ADA Curb Ramp New Construction Inspection Form (Parallel)

309th	24952.54			Cottage
North-South Road Name	Project No.	Sheet No.	Intersection No.	East-West Road Name

PARALLEL RAMP (PL)

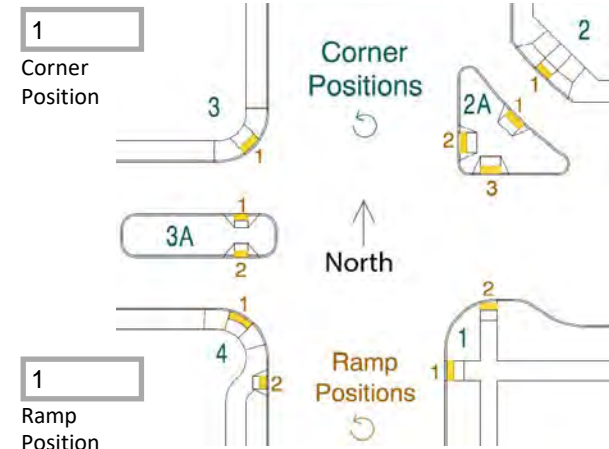
RAMP RUN 2	Pass	Fail
Running Slope 2	8.4 $\leq 8.3\%$ <input type="checkbox"/> $> 8.3\%$ <input checked="" type="checkbox"/>	
Length 2	12.8 <input type="checkbox"/>	
Cross Slope 2	<input type="checkbox"/> $\leq 2.0\%$ <input type="checkbox"/> $> 2.0\%$ <input type="checkbox"/>

RAMP RUN 3	Pass	Fail
Running Slope 3	<input type="checkbox"/> $\leq 8.3\%$ <input type="checkbox"/> $> 8.3\%$ <input type="checkbox"/>	
Length 3	9.2 <input type="checkbox"/>	
Cross Slope 3	2.2 $\leq 2.0\%$ <input type="checkbox"/> $> 2.0\%$ <input checked="" type="checkbox"/>
